PROJECT THE WORLD TRADE CENTER | TITLE REVISION AFTER FABRICATION - DETAIL 925 | DATE 3-13-69

19-AB-925

Clip Detail

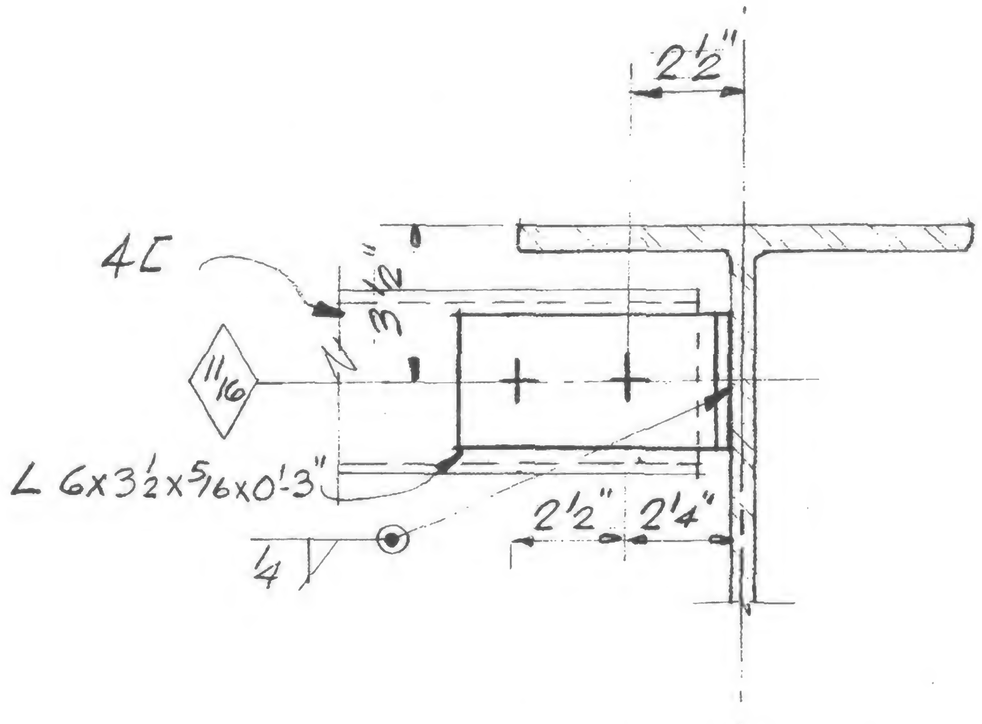
2 existing 4C's relocated floor 7, Tower A, & 2 relocated floor 7, Tower B
Abandon existing clips & furnish and install 4 new clips each tower.
See clip detail above and see SA-15 & SB-15 for location.
